APPENDIX I U.S. Department of Interior, Fish & Wildlife Service, Comments on Avoidance Minimization and Compensation Measures, dated December 17, 2007

In reply refer to: 81420-2008-TA-0496

Comments on Proposed Avoidance, Minimization, and Compensation Measures

for Madera Ranch Quarry Project (Madera County, California)

Exhibit A

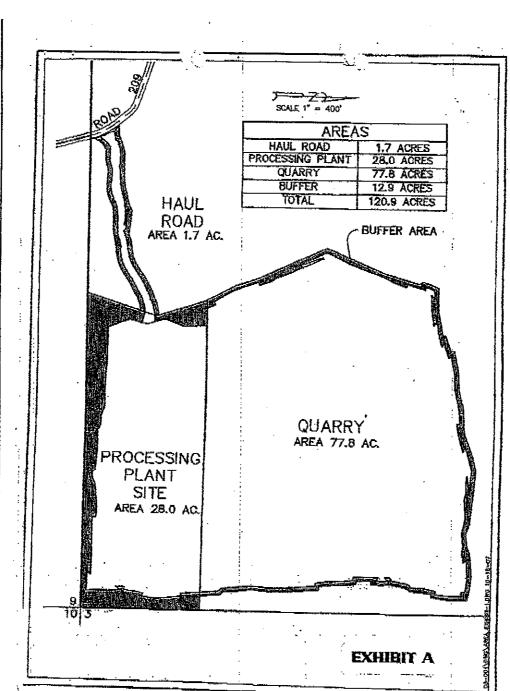
- 1. Attached as Exhibit "A" is a drawing of MQI's Madera Property (Ranch) showing the disturbance of 120.9 acres. There is an additional 14.54 acres which will be disturbed by MQI's realignment of County Road 209. The total disturbed area is approximately 135 acres. MQI shall mitigate for the loss of salamander habitat by the creation of the permanent easement referred to in Item 3.

Exhibit B

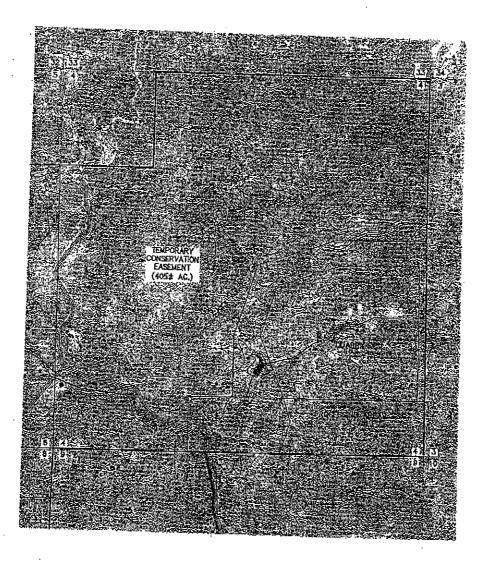
- 2. Temporary Conservation Easement (TCE) as Security Pending the Establishment of a Permanent Conservation Easement (PCE). While MQI is undertaking those activities referred to in Item 3 for the creation of the PCE, it shall create a TCE on a minimum of 405 acres of upland habitat, as shown on Exhibit "B". The purpose of creating the TCE is to afford MQI time to undertake the activities referred to in Item 3. These activities will be undertaken after the Army Corps of Engineers issues its permit for MQI's quarry project. The easement holder shall be acceptable to the Service.

Exhibit C

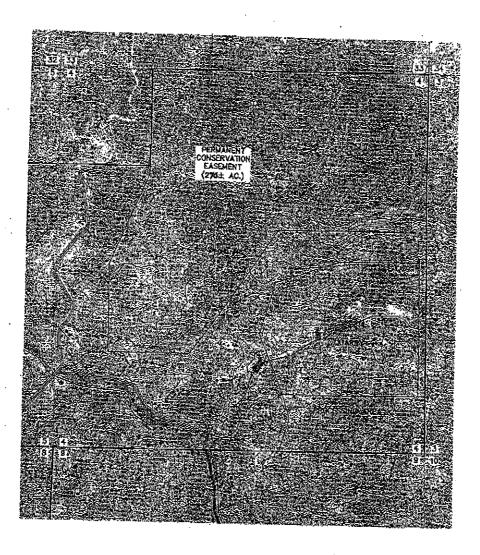
- b. Dedicate the PCE to an agency acceptable to the Service. The PCE shall be for that portion of the Ranch as shown as PCE on Exhibit "C" and comprising Contingent Conservation Measures a minimum of 270 acres. This shall be done simultaneously with the Service extinguishing the TCE.
